MISSISSIPPI POWER & LIGHT COMPANY

SUBJECT: Grand Gulf Nuclear Station  
Units 1 and 2  
Docket Nos. 50-416 and 50-417  
File 0260/0862/L-340.0/L-334.0  
Transmittal of Proposed FSAR  
Changes and Responses to  
NRC Formal and Informal  
Questions  
AECM-81/345

- Attachments:
1. Question and Response 260.1
  2. Revised Question and Response 362.7
  3. HGEB SER Open Item - Ultimate Heat Sink
  4. NRC Concern - Shared Systems
  5. SER Open Item - Soil-Structure Interaction

The response to this question is given in revised subsection 2.5.4.13.1, revised Table 2.5-10, and revised Figures 2.5-75a through 2.5-75h.

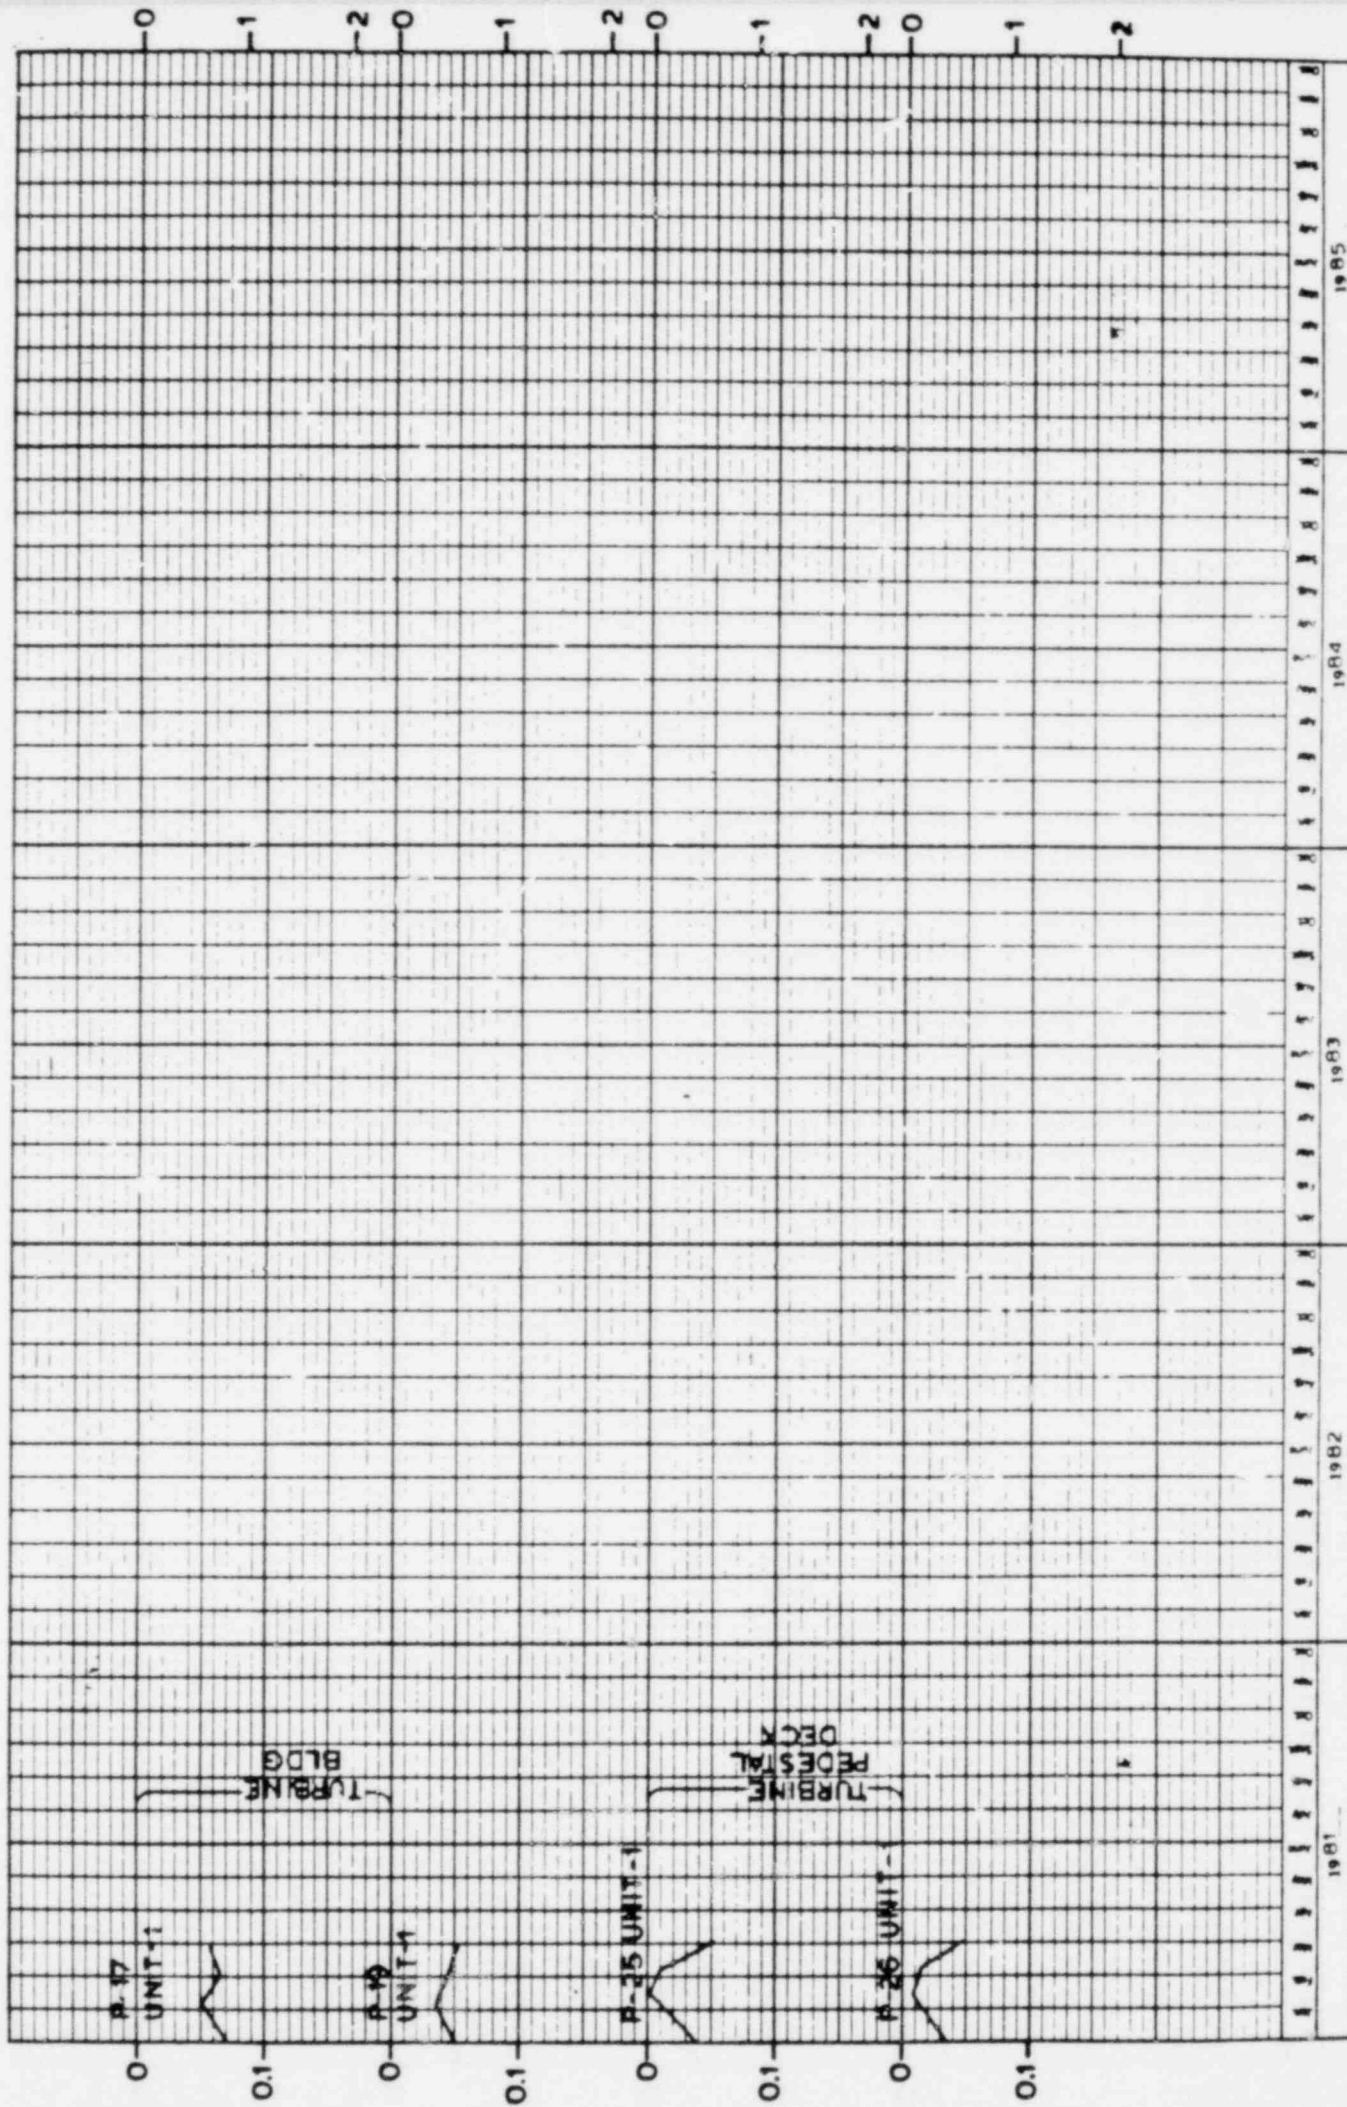
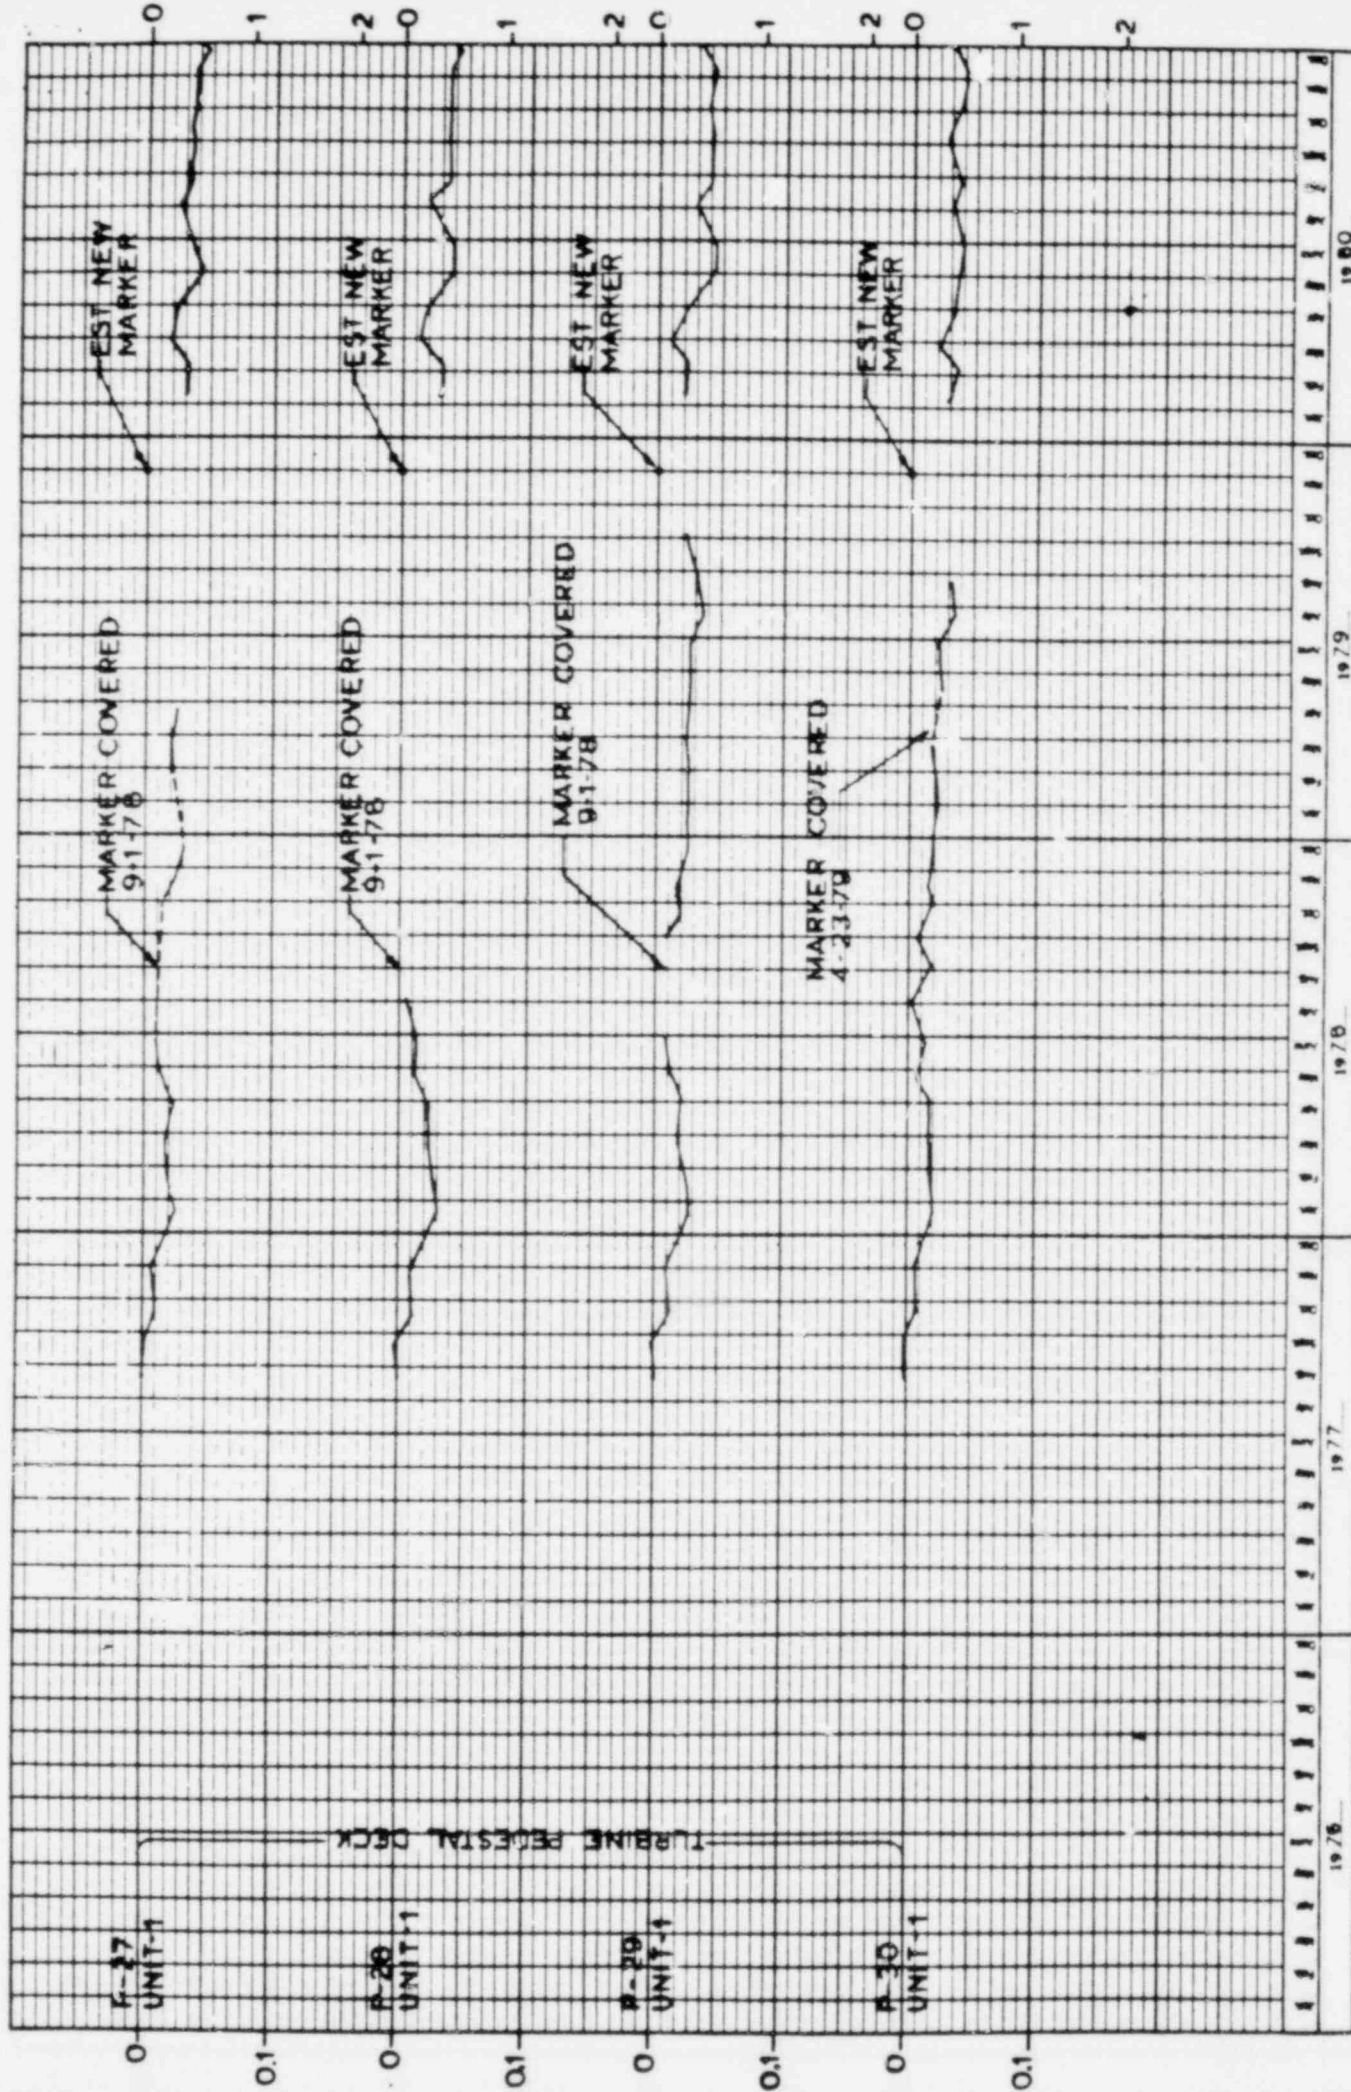
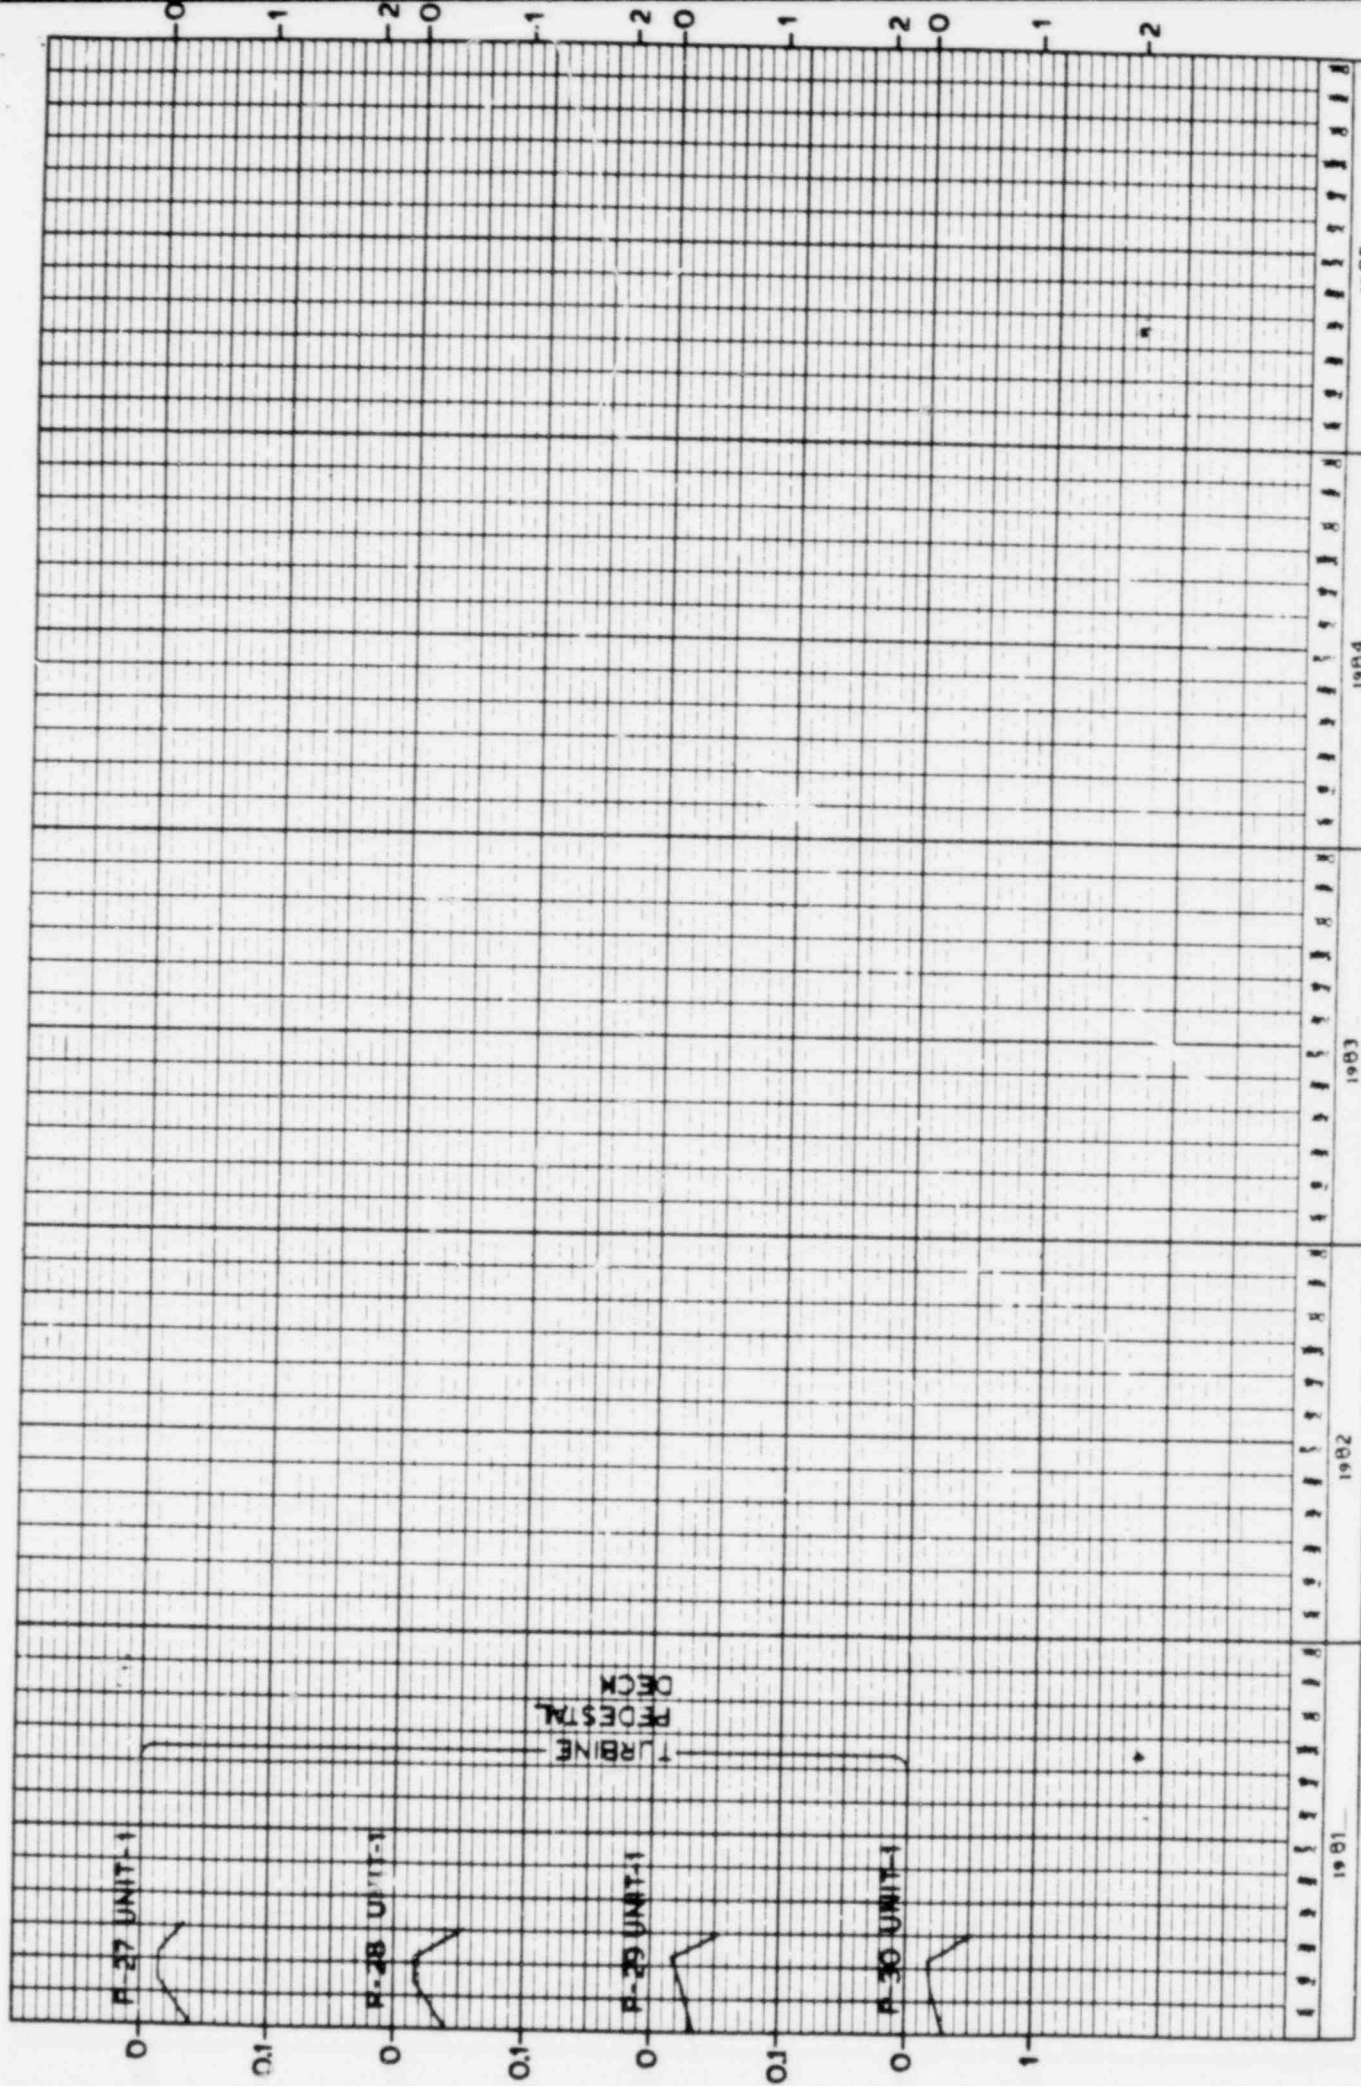
362.7 Your response to NRC Question 362.5 (page Q&R 2.5-14, Amendment 30) is not complete. Indicate what measured value of differential settlement would cause code allowable stresses to be exceeded for individual buildings and buried piping and require notification of NRC. Provide a table of these values and the limiting stress criteria. Update the plots which show settlement recorded to date versus time; this is particularly important since construction of Unit 2 was still underway when your response to Question 362.5 was being developed.

The settlement markers will be read at one-month intervals until construction is complete and all pools are filled with water, at which time the results of the settlement monitoring program will be evaluated and long-term monitoring of the structures will be assessed. Total settlement will not be a Geotechnical concern until the following measured values are observed:

Turbine building	3"
Radwaste building	3"
Control building	3"
Containment building	3.5"
Auxiliary building	3.5"
Diesel generator building	3"
